MEMORANDUM

RE: IGWA's 3rd Mitigation Plan: Flow Measurements at Sandy Ponds and Aquifer Recharge Measurement, Response Memo to February 17, 2015 IDWR Staff Memorandum/comments regarding IGWA's 3rd Mitigation Plan

SANDY PONDS MEASUREMENT PROJECT
IGWA

NSCC VEENSTRA DELIVERY DITCH PROFILE

EXHIBIT A
VEENSTRA DITCH PROFILE

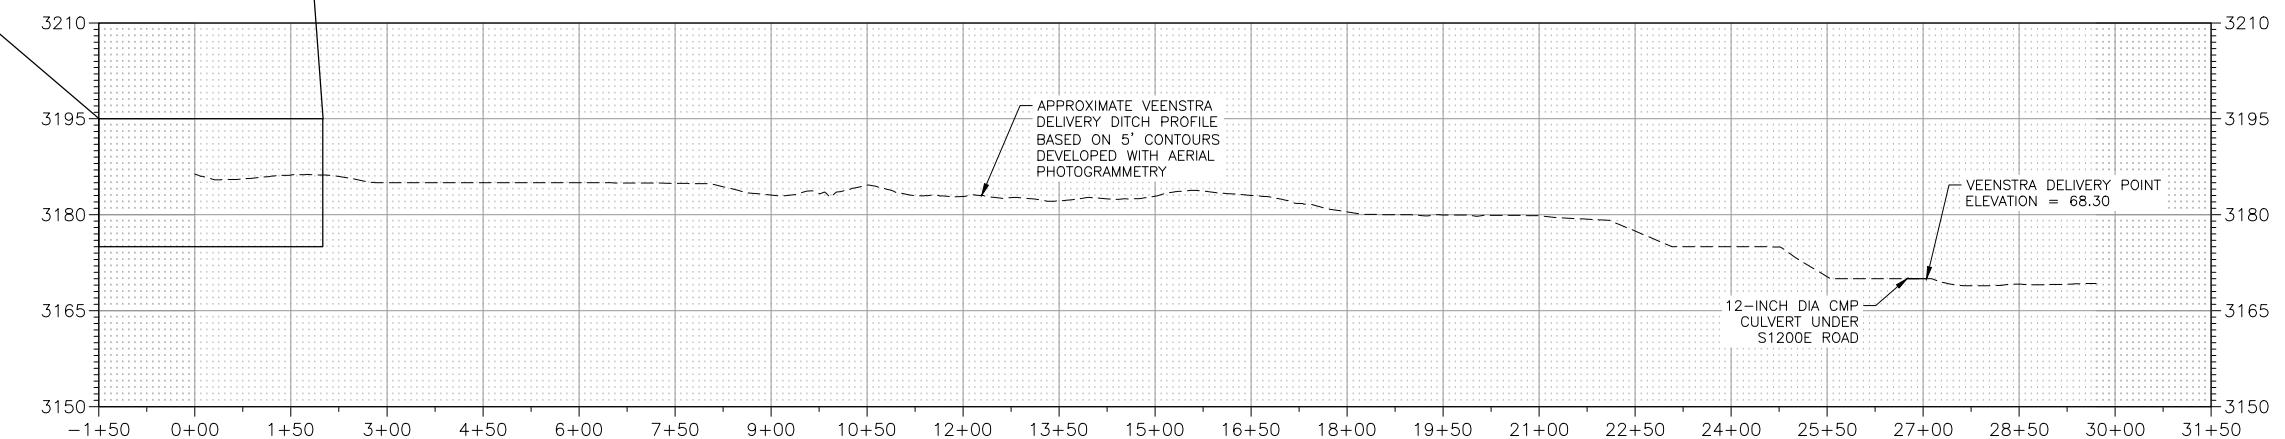
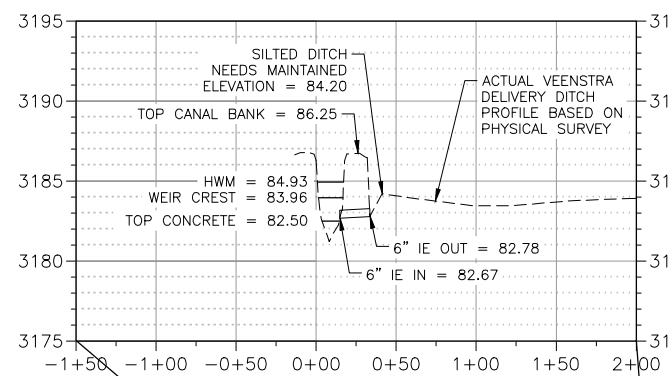
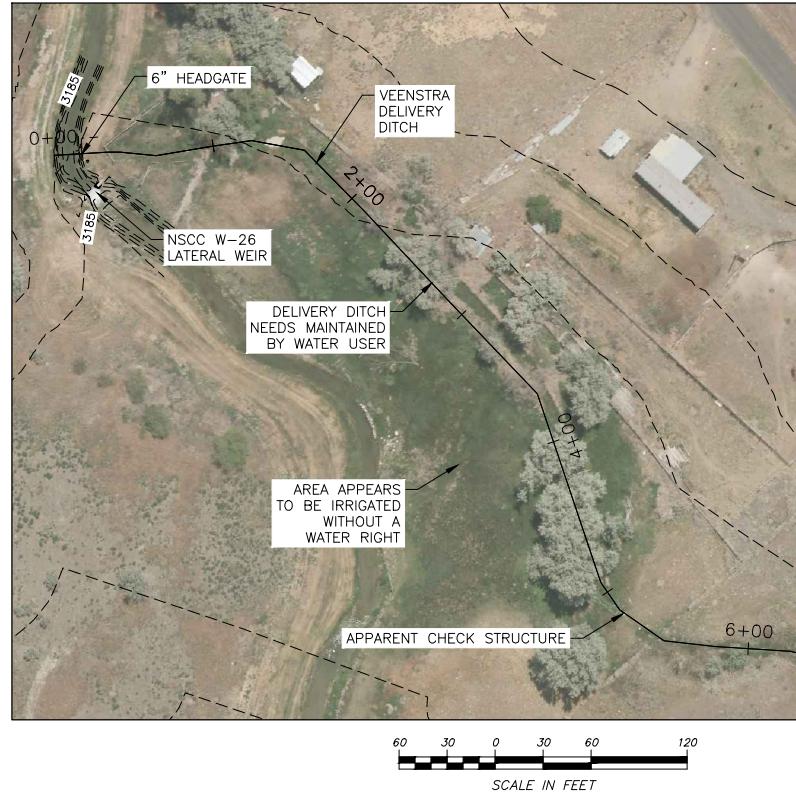
1. Existing weir used as a check structure: Through discussions with Alan Hansten at NSCC and field observations, SPF agrees the weir structure is also used as a check structure for the small headgate directly upstream of the weir. The headgate delivers water to the Veenstra property downstream, which according to IDWR records is entitled to 0.12 cfs of waste water for irrigation. SPF agrees that the placement of check boards would invalidate weir measurements. To check the necessity of placing check boards in the structure, SPF completed field survey of the Veenstra delivery ditch and has determined sufficient slope from the headgate to the Veenstra place of use is available if the ditch were to be maintained (see attached Exhibit A showing the ditch profile). SPF has also determined that if the ditch were maintained, the current height setting of the weir blade is approximately 0.85 feet higher than that necessary to provide adequate head for the delivery and the use of check boards is not necessary.
